ADDENDUM 3

DATE: May 12, 2017
PROJECT: Tashman Dry Lab Construction
ITB NO: 744-B1716
OWNER: The University of Texas Health Science Center at Houston
TO: Prospective Proposers

This Addendum forms part of and modifies Proposal Documents dated, April 7, 2017, with amendments and additions noted below.

Print Date / Time: 5/11/2017 1:56:58 PM
P&W Commission Number: 216-042
Sheet Number: A-112

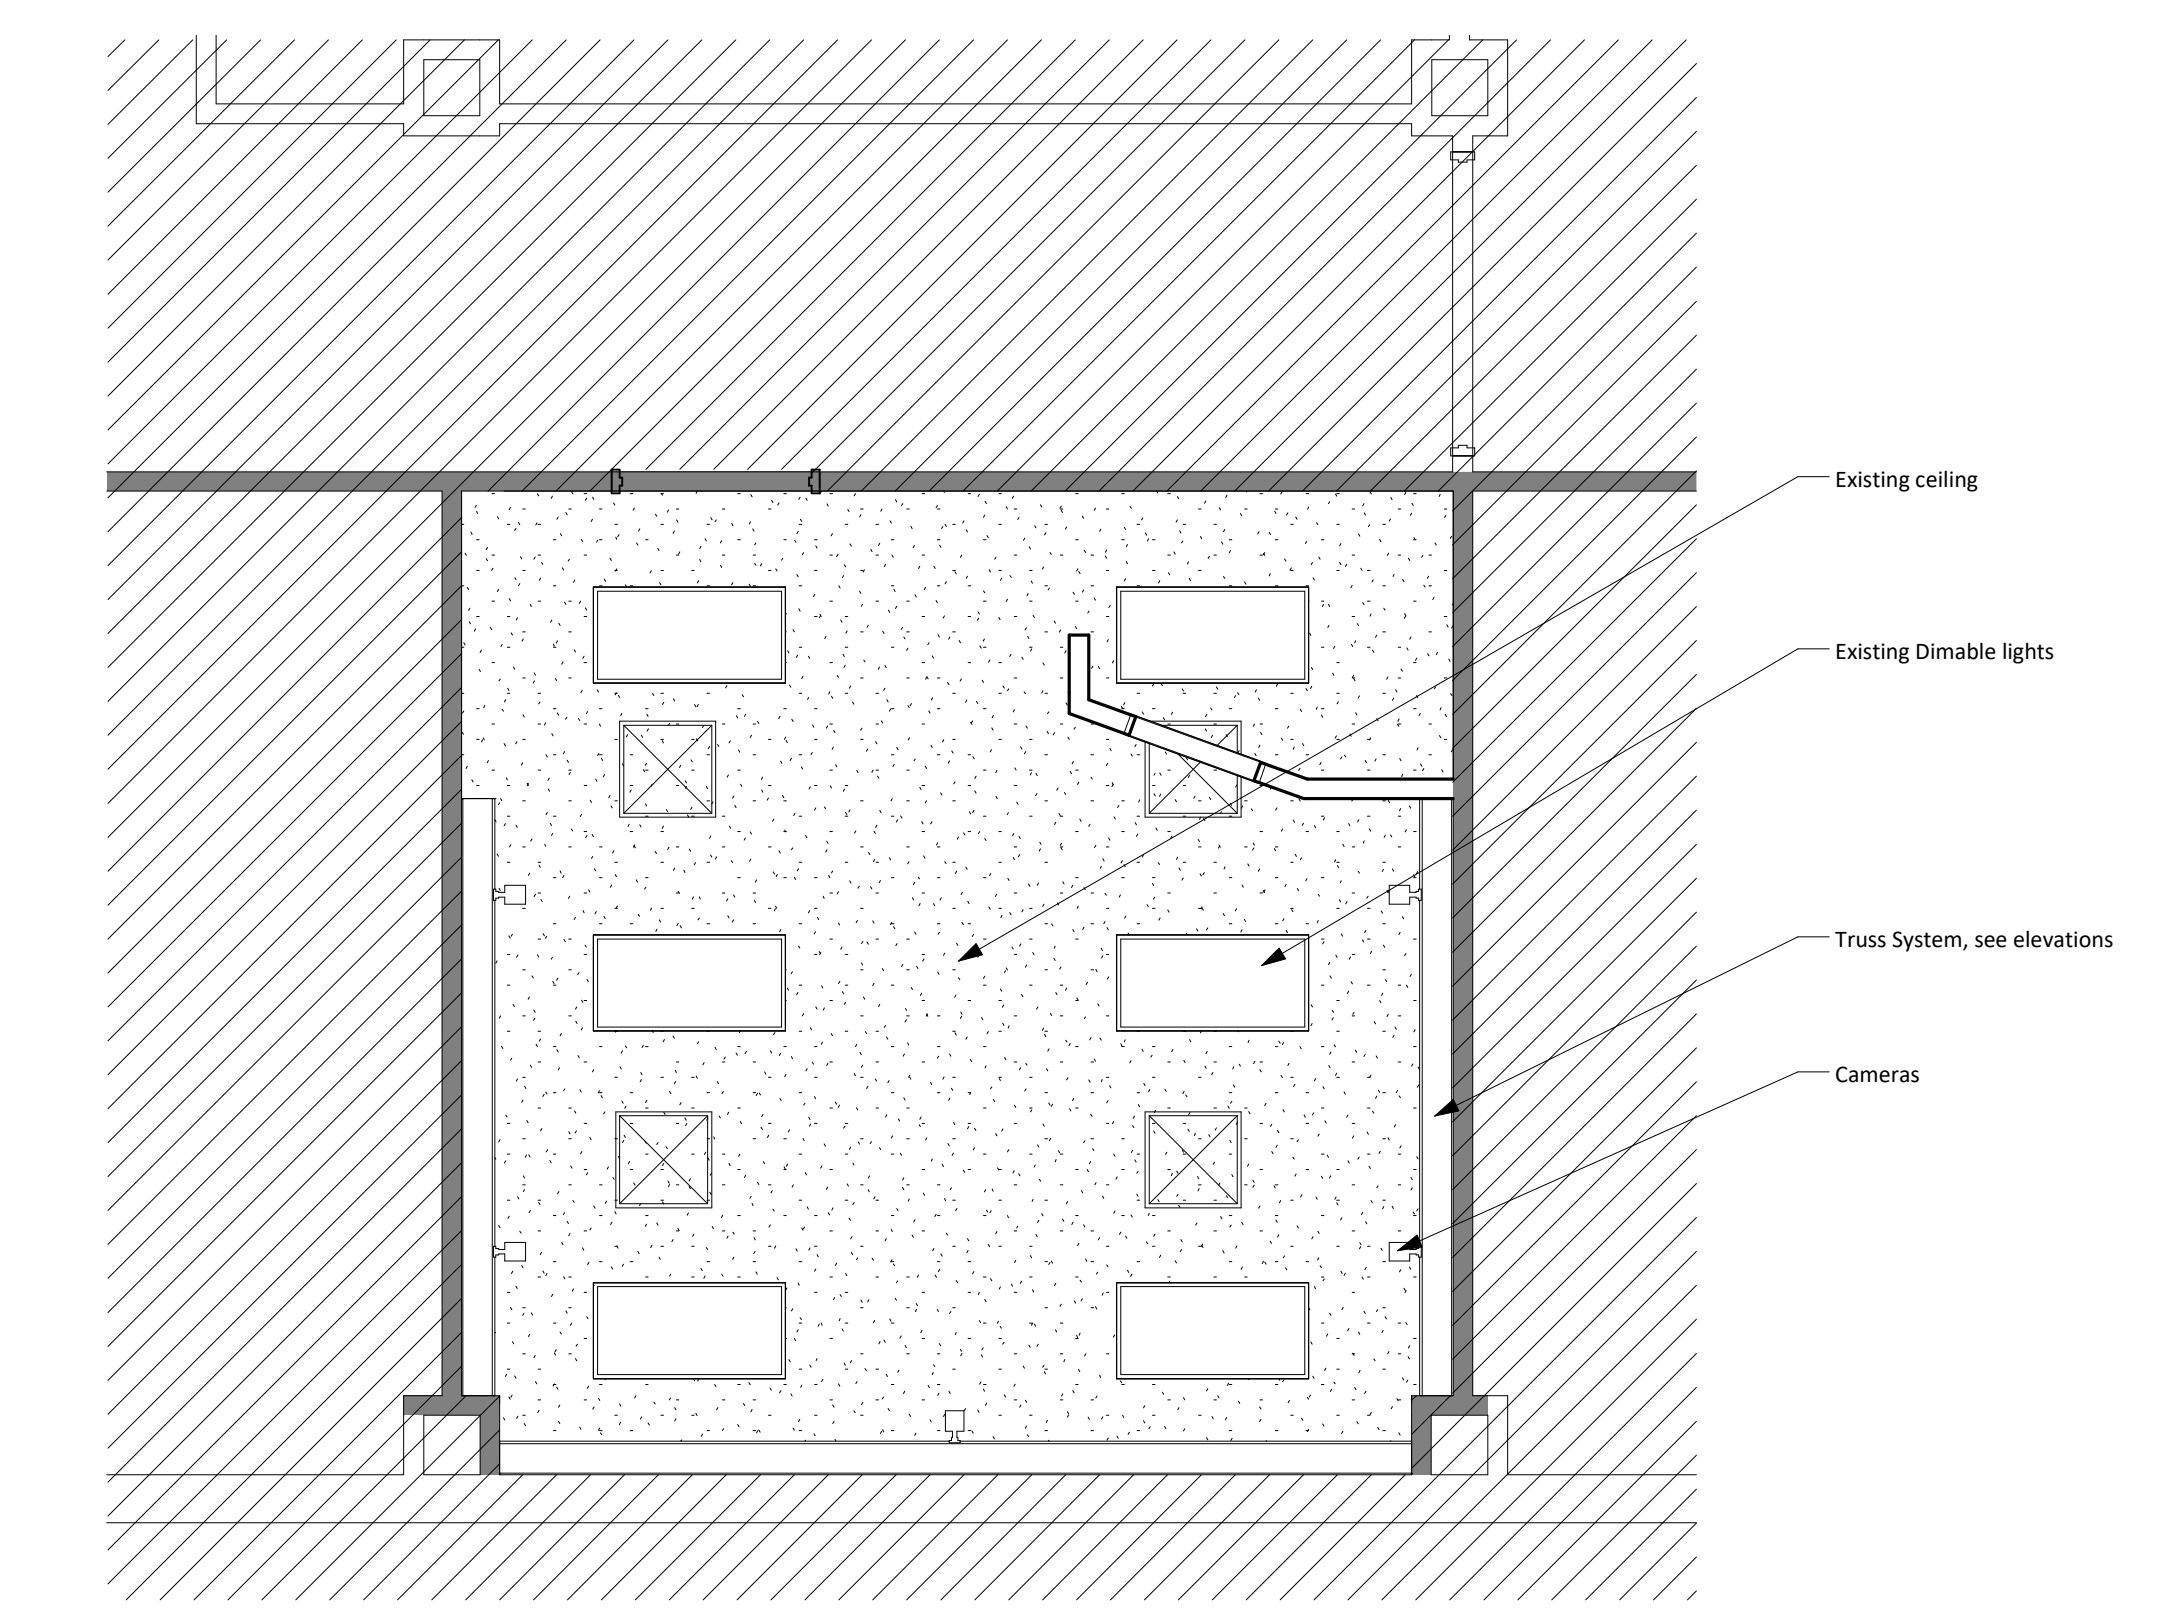
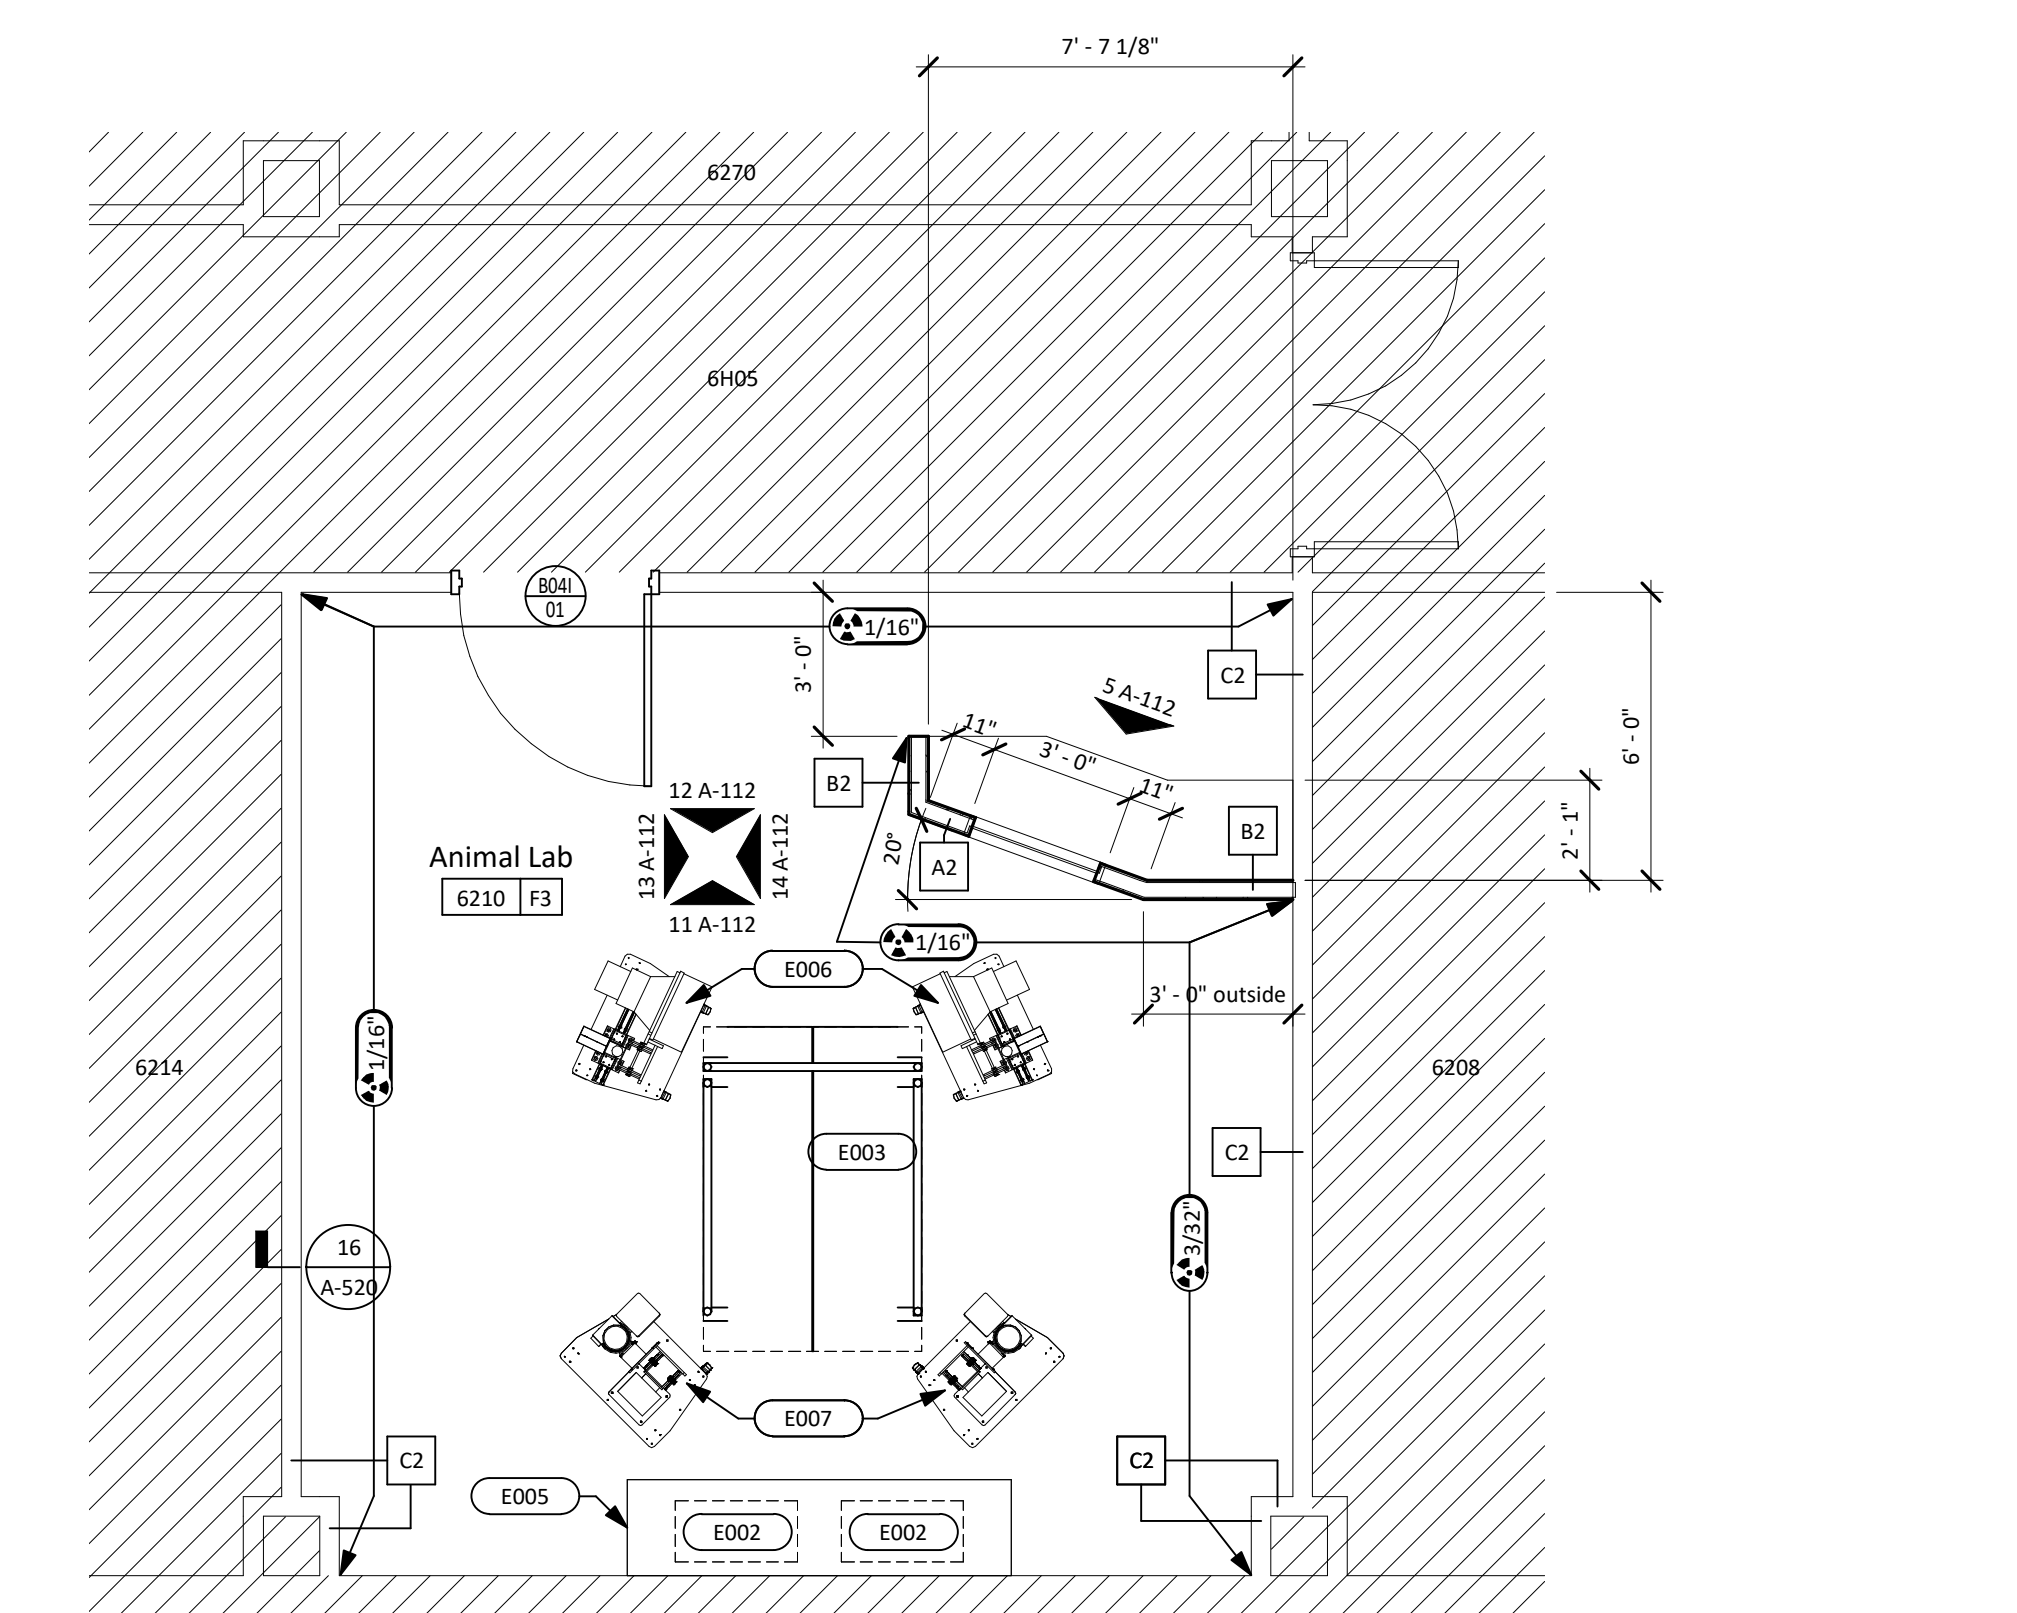
15) Drawing A-112 does not seem to indicate the lead shielding thickness of the South wall in Animal Lab 6210. Will lead shielding be required in this wall? If so, what thickness will it need to be?

Answer: Per the shielding report, no shielding required at this wall. Please refer to Shielding Specifications below for both labs.

01 PARTIAL POWER RISER DIAGRAM

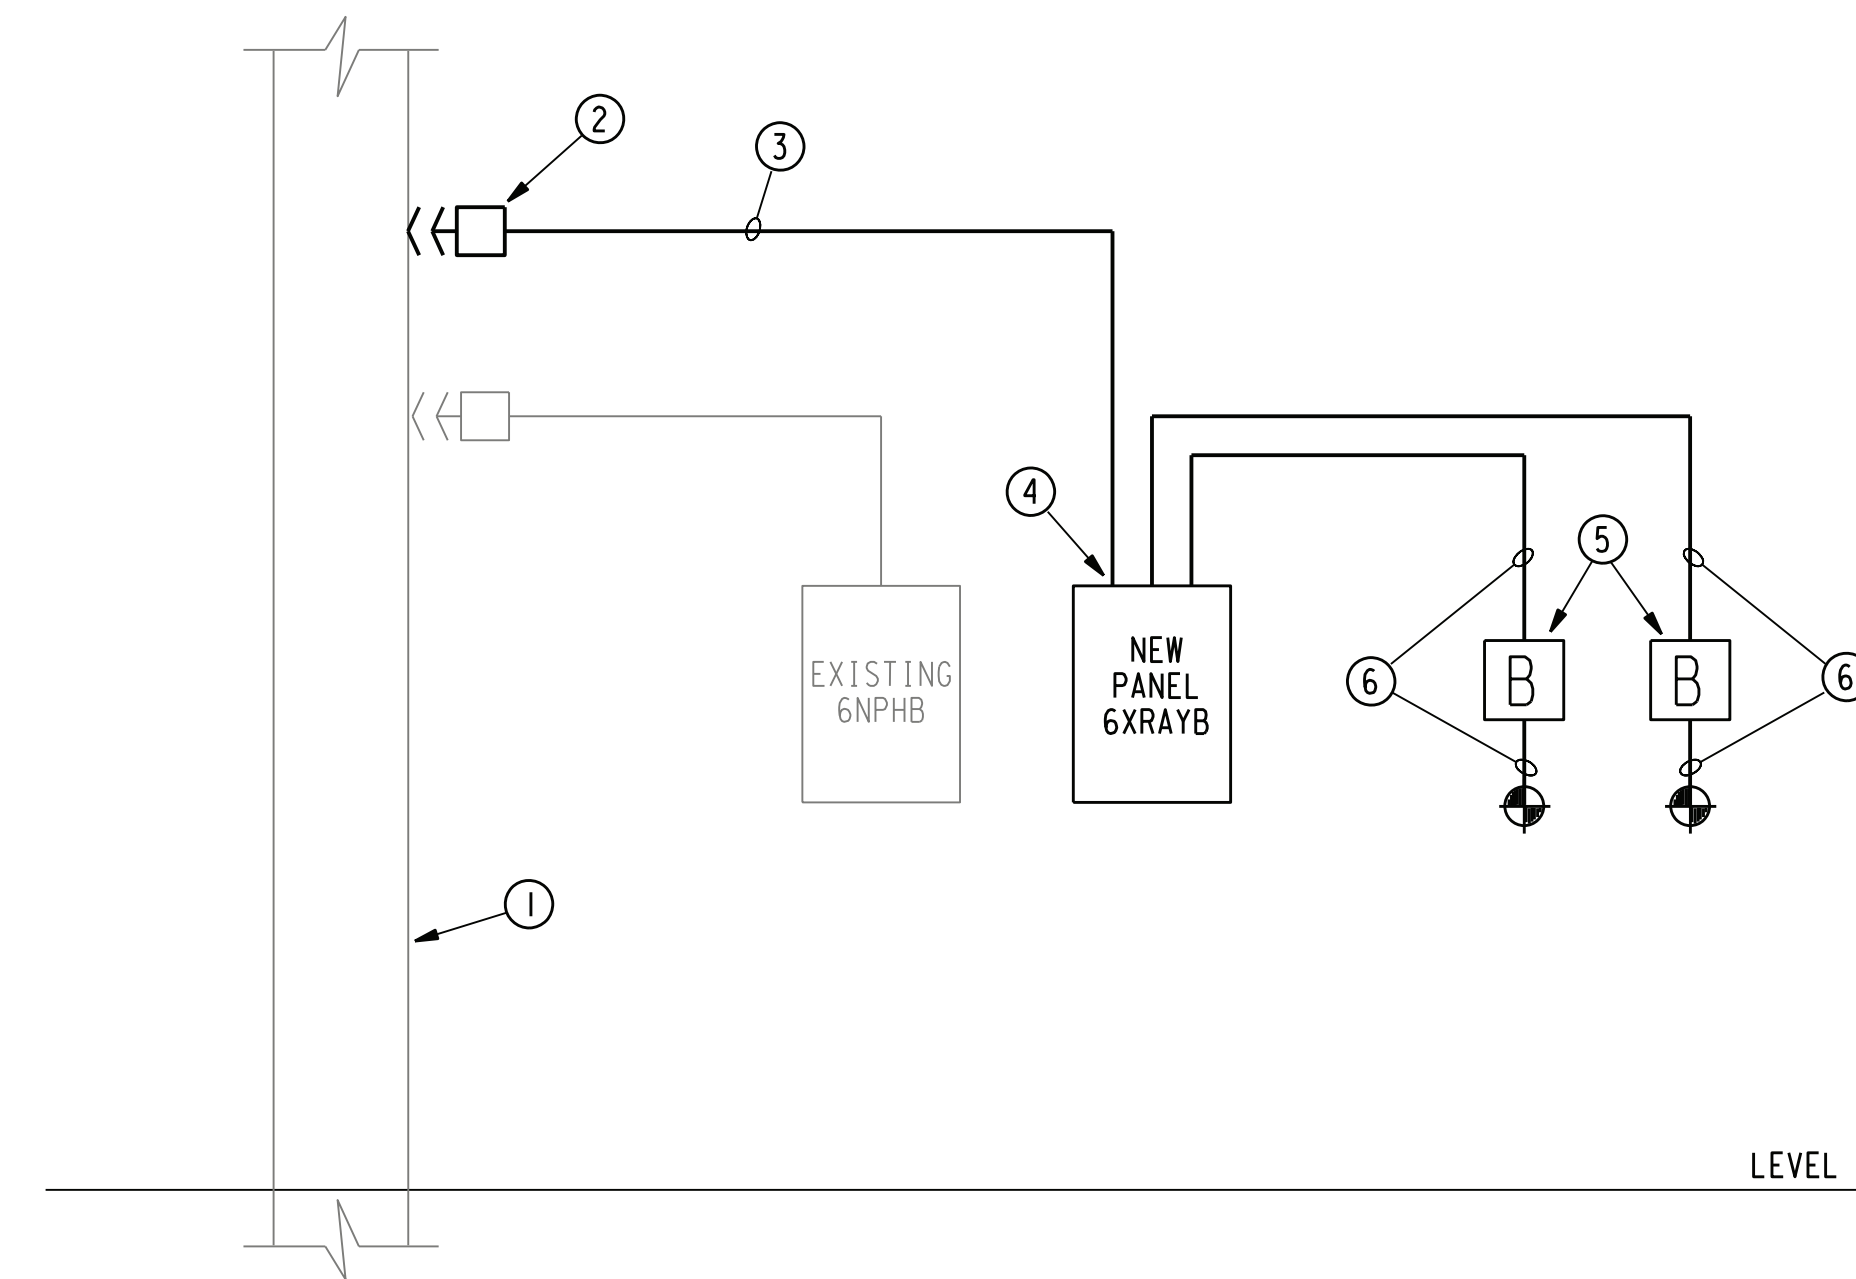
Answer: Aluminum truss to be provided and installed by the contractor. See Addendum for manufacturer and model.
- 14) Regarding page EP-300B, Section 01 – Partial Riser Diagram: Please specify the manufacturer/type of the existing busway to tie into.

Answer: We do not have this information, contractor to verify.

Report on Shielding Specifications for SCRB3 Research Lab

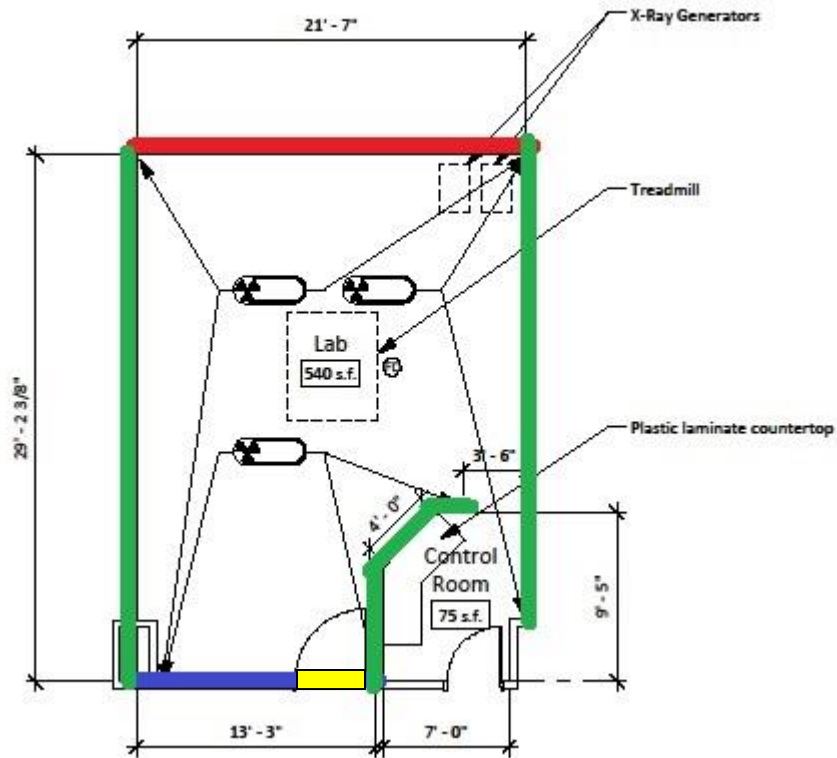
The diagram below specifies the shielding recommendations:

Wall indicated by **RED** solid line requires 1/8th-inch lead shielding. It can be achieved by putting 1/16th inch lead equivalent sheetrock on both side of existing sheetrock.

Walls indicated by **GREEN** solid line require 3/32nd-inch lead-equivalent sheetrock. (window on control wall must be have same lead-equivalent as wall).

Wall indicated by **BLUE** solid line requires 1/16th-inch lead-equivalent sheetrock or 1/32nd-inch leaded door.

Door indicated by **YELLOW** solid line requires 1/32nd-inch leaded door.

Report on Shielding Specifications for BBSB Animal Lab

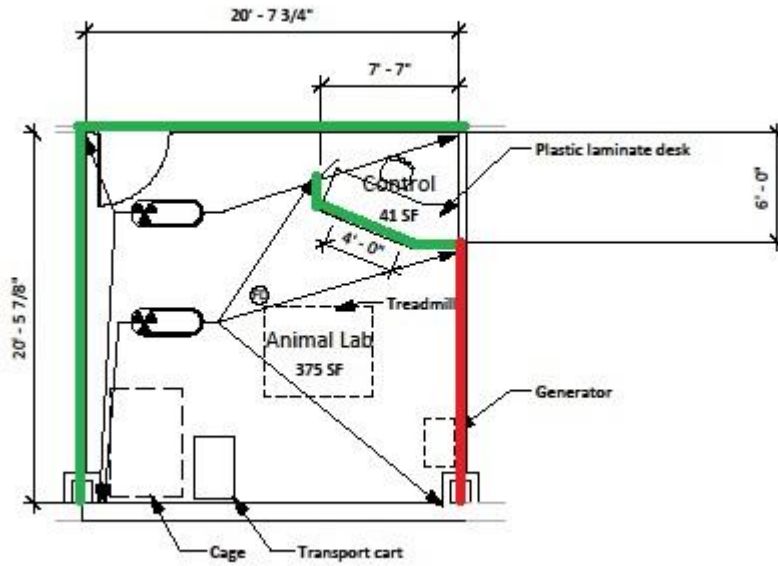
The diagram below specifies the shielding recommendations:

Wall indicated by **RED** solid line requires 3/32-inch lead-equivalent sheetrock.
